PL2018-343

BUILDING ADDITION

LYNDALE OFFICE
BLOOMINGTON, MINNESOTA

SITE PLAN

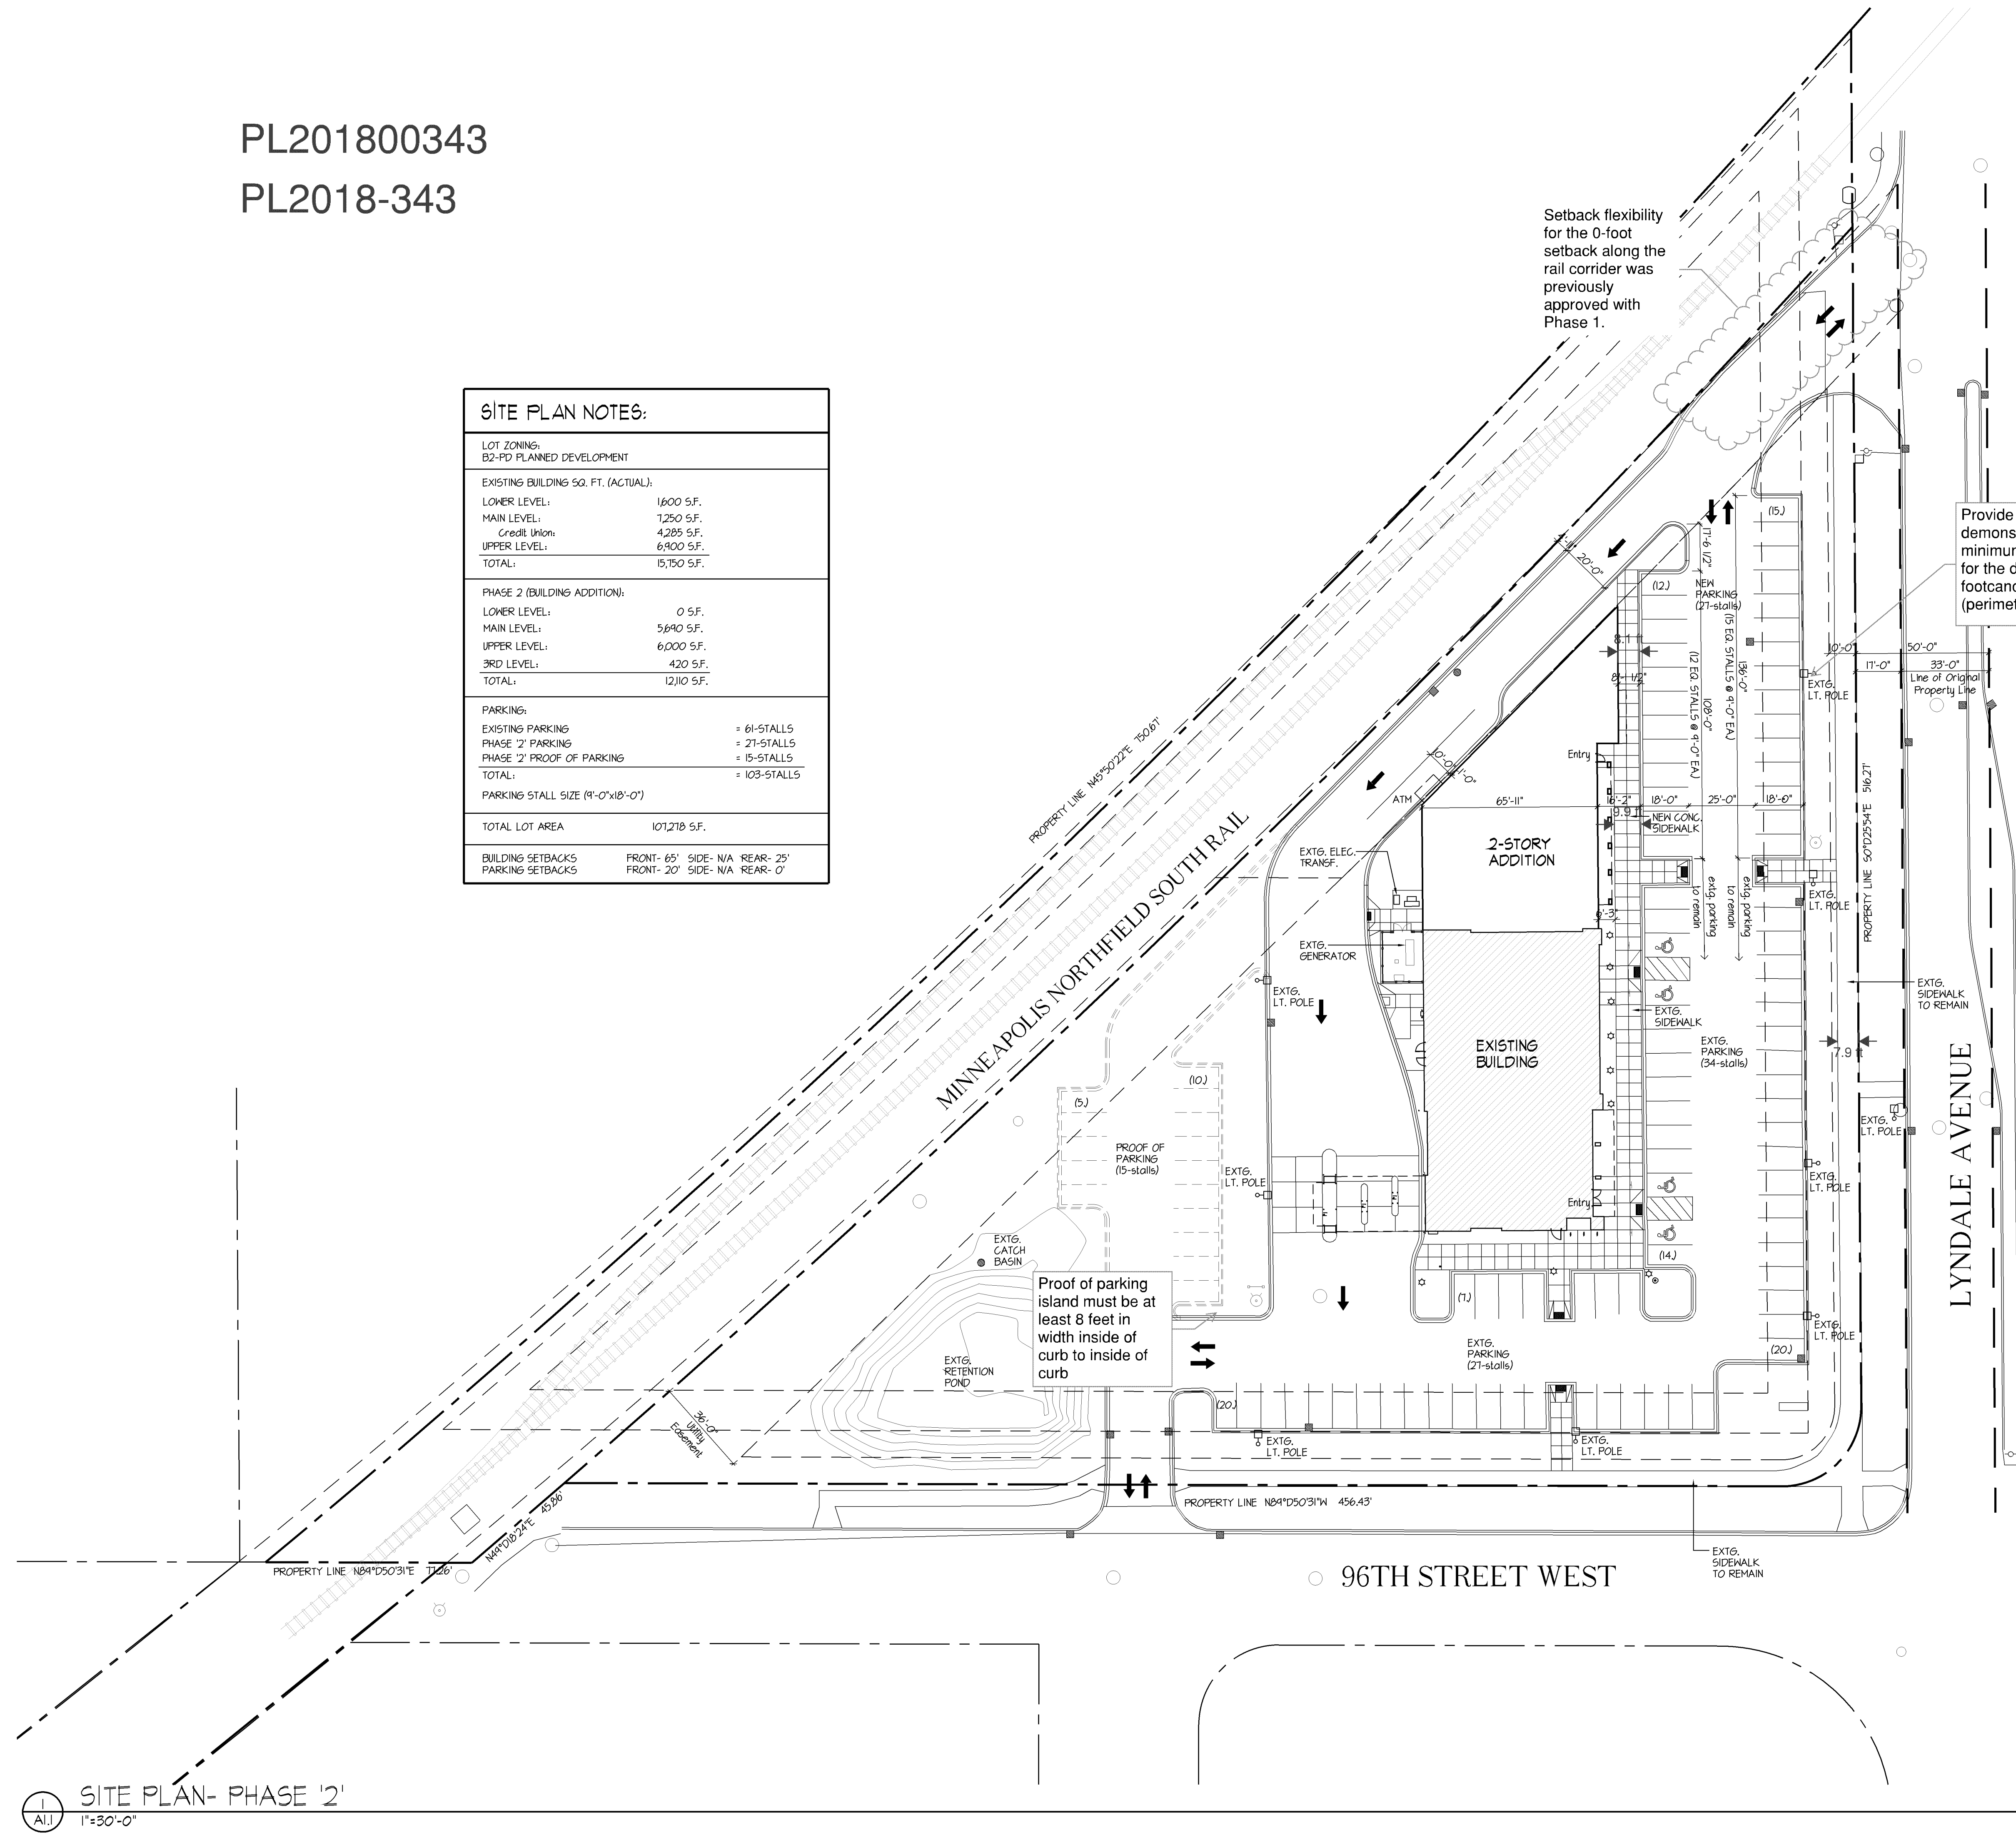
Provide a photometric plan that demonstrates the new parking area meets minimum lighting. 2.0 footcandles is required for the driveway and west stalls. 1.0 footcandle is required for the eastern stalls (perimeter stalls).

SITE PLAN- PHASE '3'
1"=30'-0"

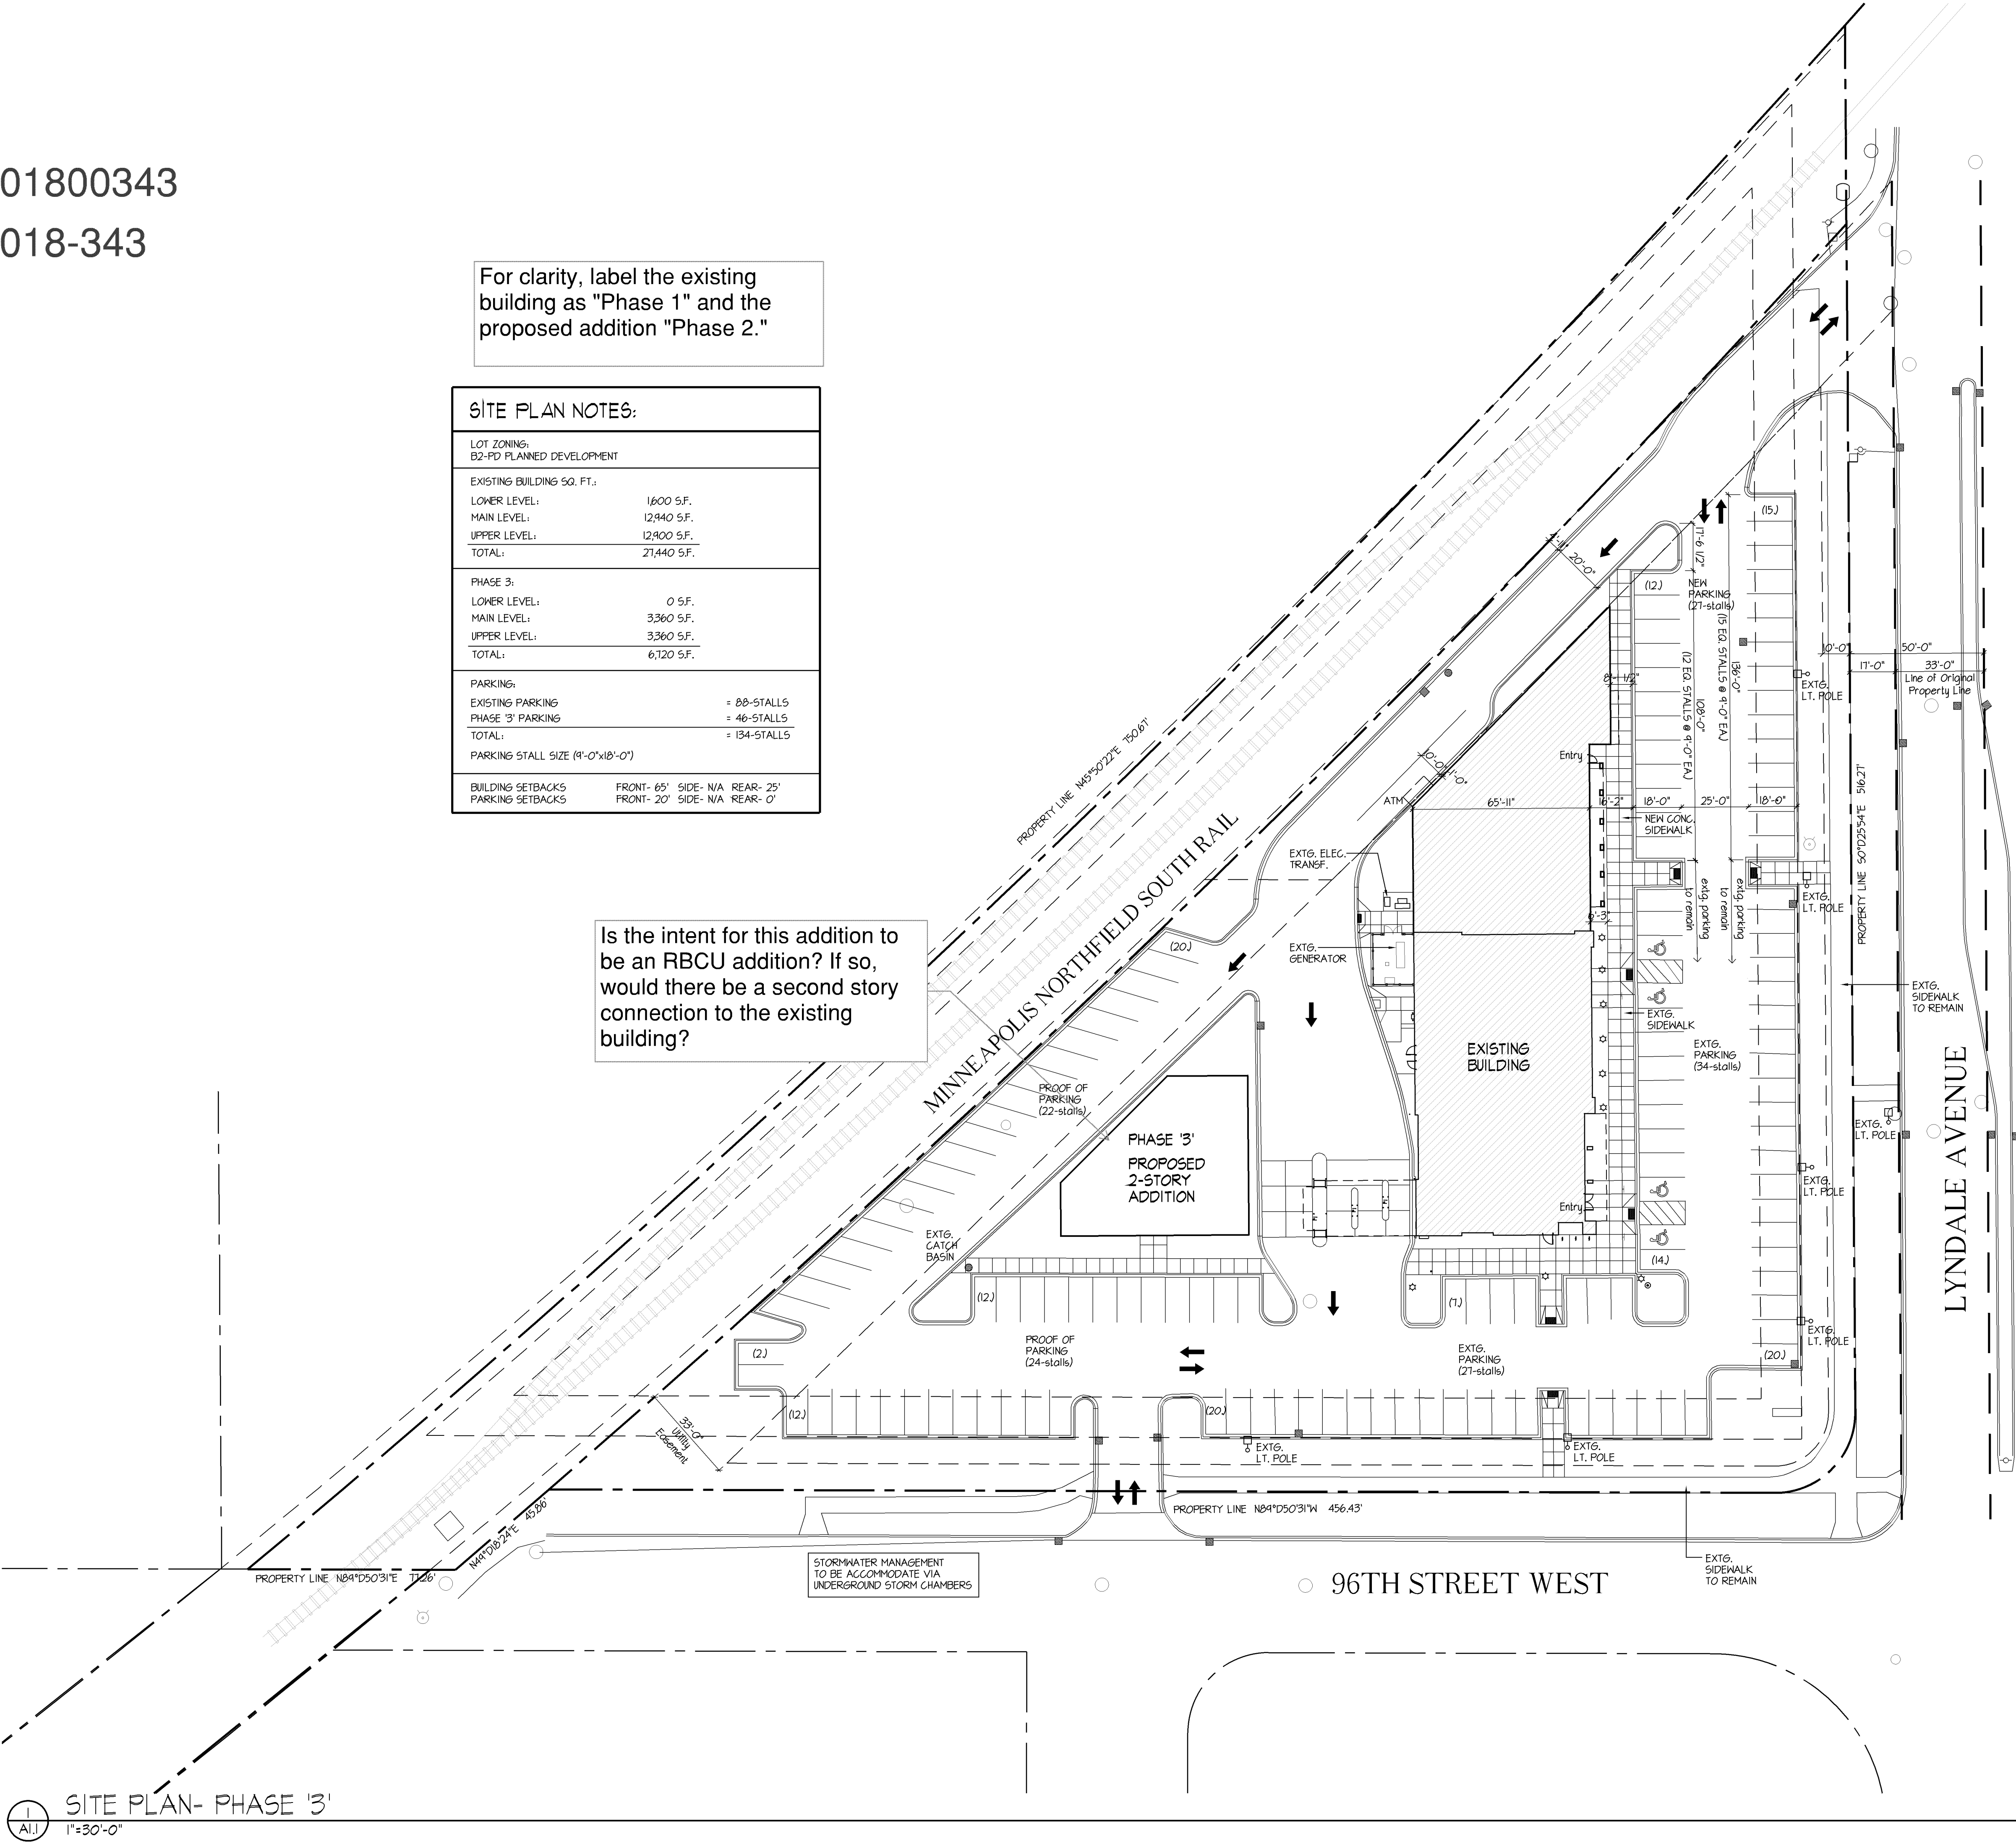
For clarity, label the existing building as "Phase 1" and the proposed addition "Phase 2."

Is the intent for this addition to be an RBCU addition? If so, would there be a second story connection to the existing building?

L1

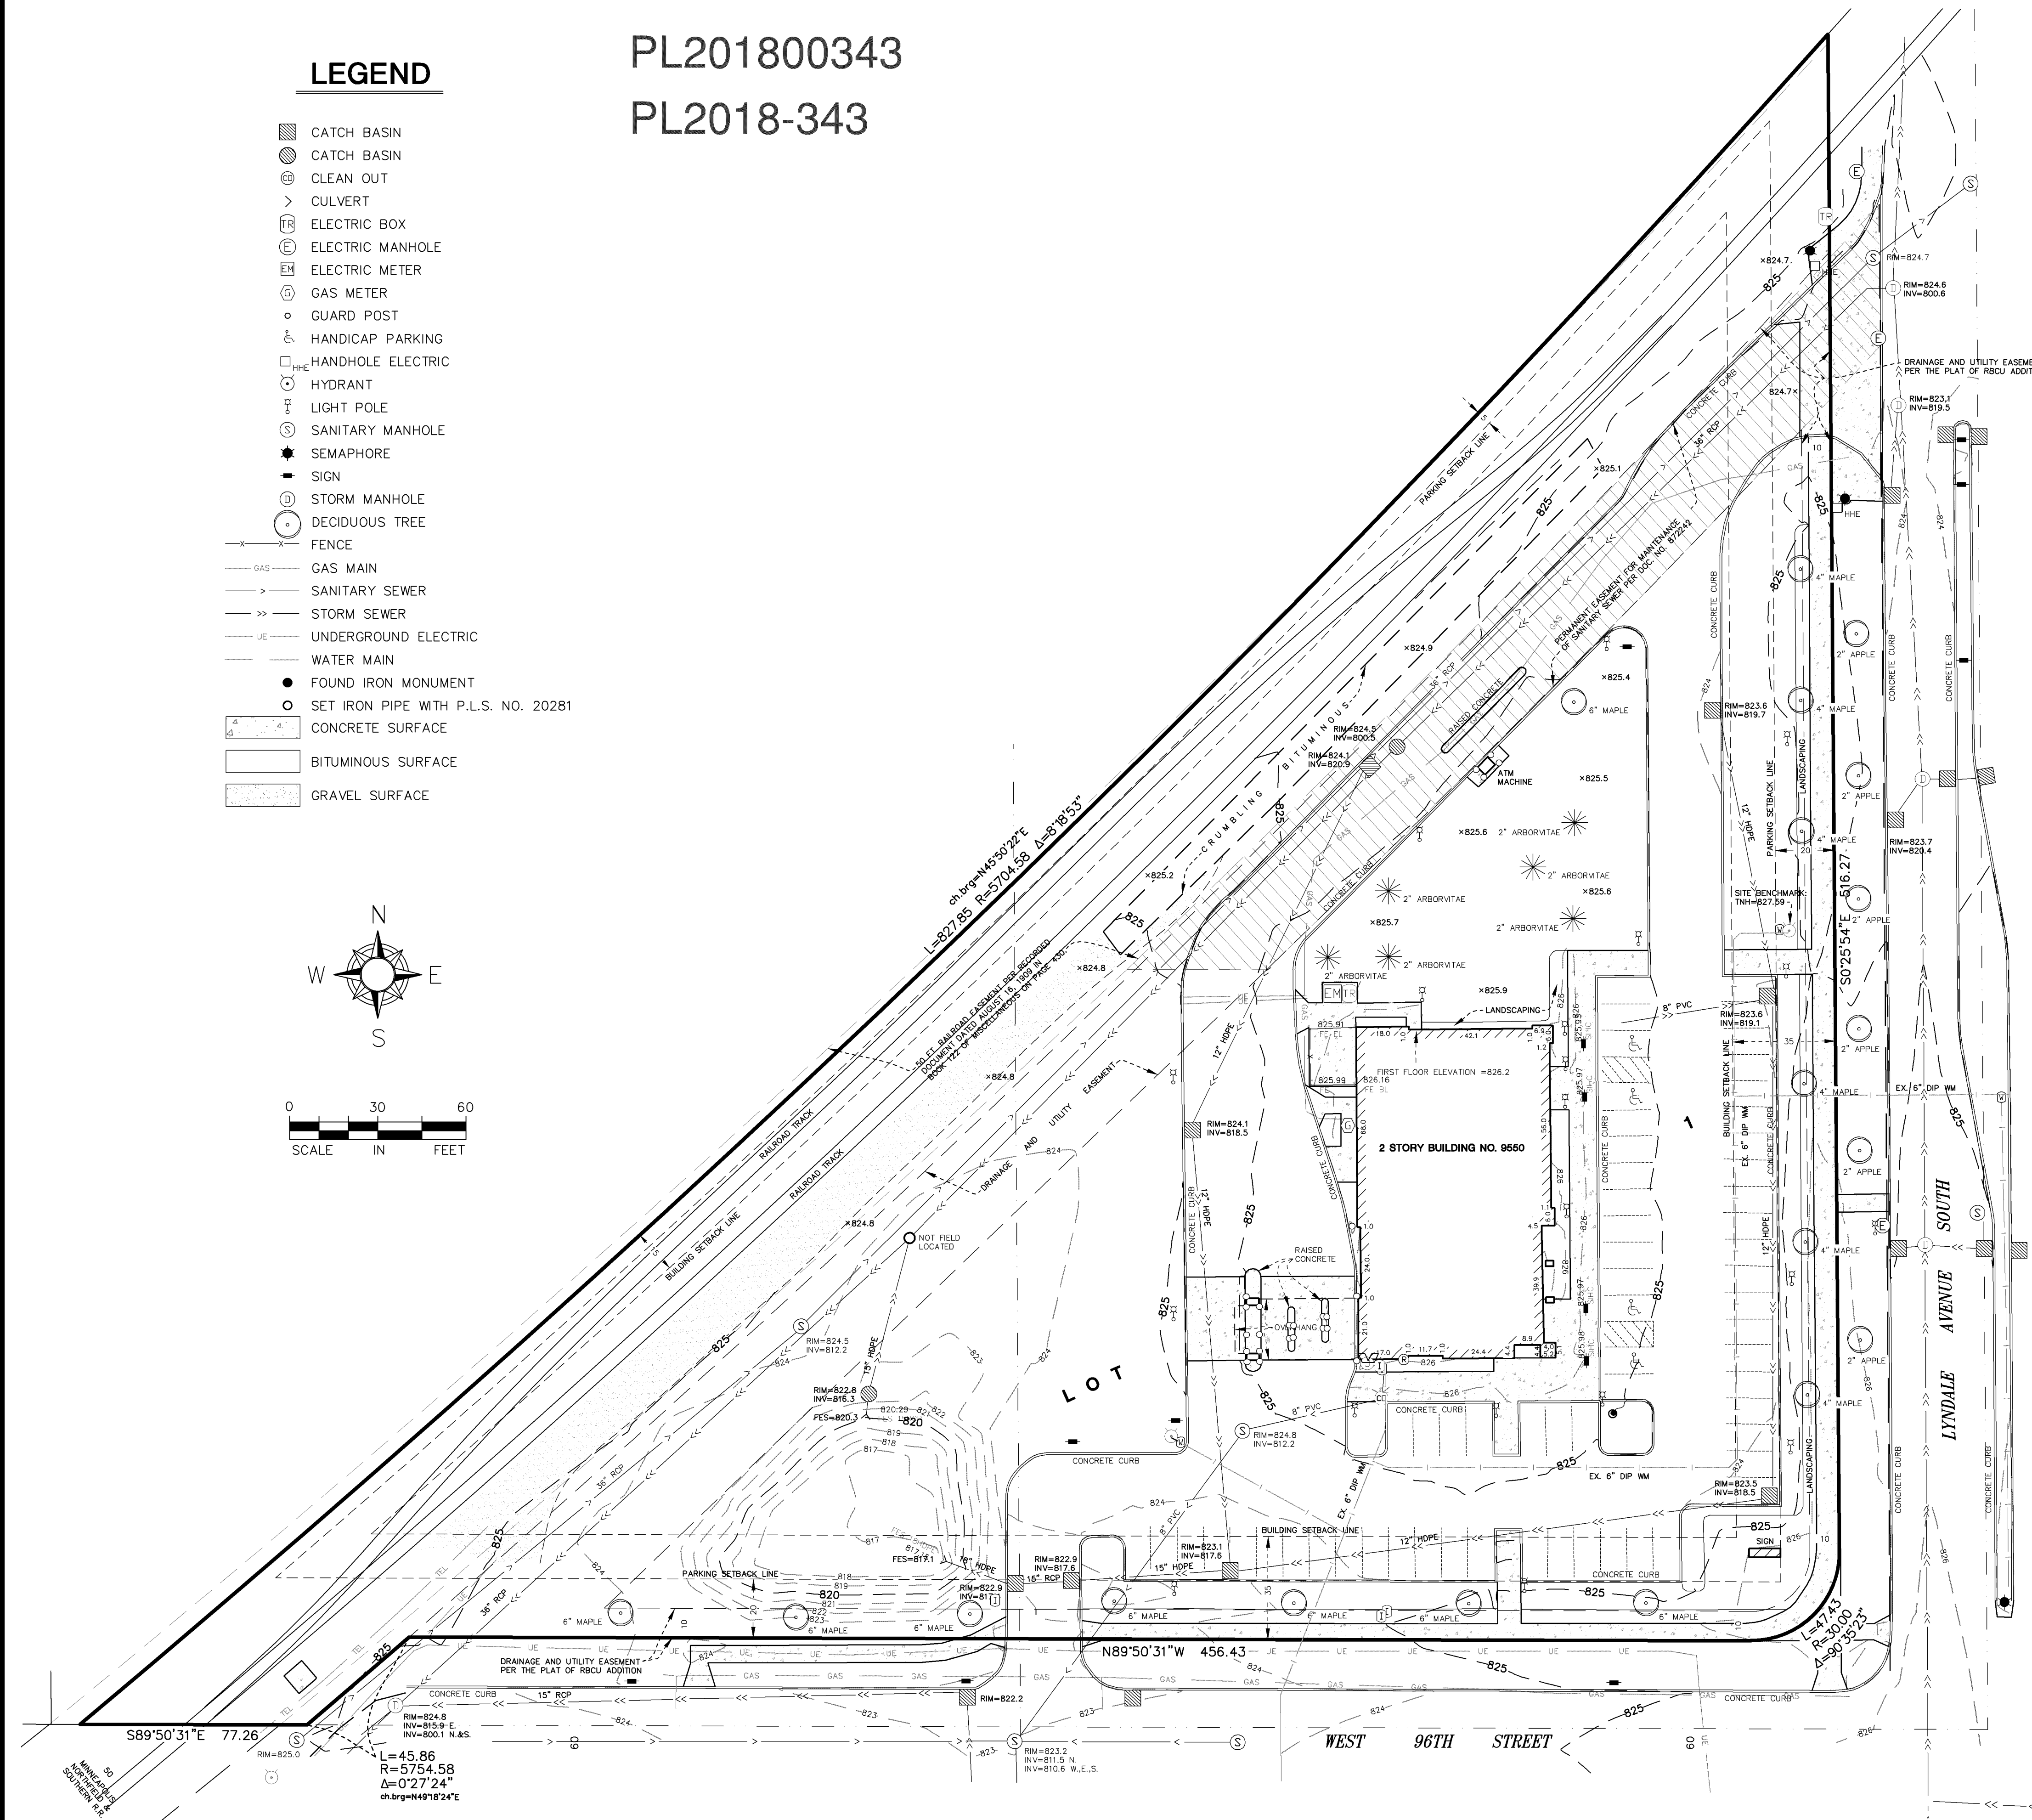
Incorporate proposed landscaping with the phase 1 landscaping plan. The entire site must meet City landscaping requirements.
